E-Series	Model Description	Production Date
F02	7 Series Sedan	Vehicles produced up to July 2011.
F04	7 Series Sedan Active Hybrid	
F10	5 Series Sedan

Vehicle has the air bag warning lamp on after a body shop has made repairs.

Air bag sensor and/or door from later model vehicle was installed.

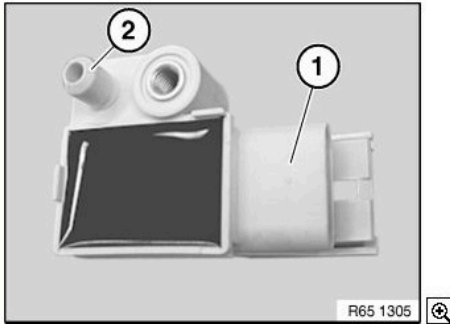
Replacement of driver or passenger front doors on vehicles up to 7/2011 requires use of original air bag sensor with the new design door. If the new style from 7/2011 sensor is used it will set an air bag fault for open circuit since it is pinned differently in the electrical connector.

The only door design available from parts is designed for vehicles produced from 7/2011 but fits the earlier vehicles.

- Install correct door pressure sensor for vehicles produced up to July 2011.
- If a new design door is used with the original sensor seal the gap between round sensor and square hole in door.

6577740 Removing and installing (replacing) left front door sensor

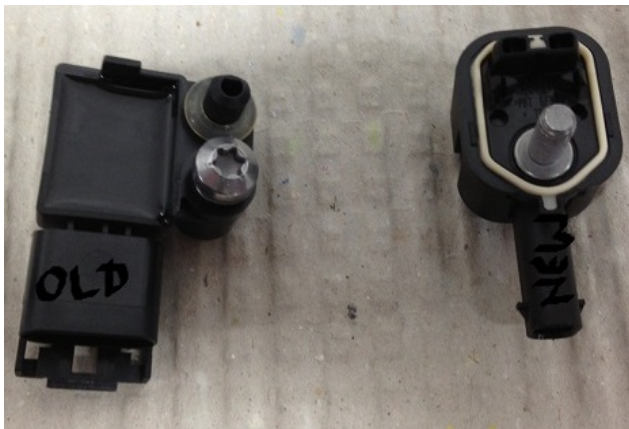
The sensor on the left is for vehicles **UP TO 7/2011**

The sensor on the right is for vehicles **FROM 7/2011**

The new design door for vehicles from 7/2011 has a square hole for the pressure sensor.

When using this door on vehicle produced up to 7/2011 you must use the original pressure sensor.

Use dynamat or other adhesive mat to seal air gap between round grommet on sensor and square hole in door.
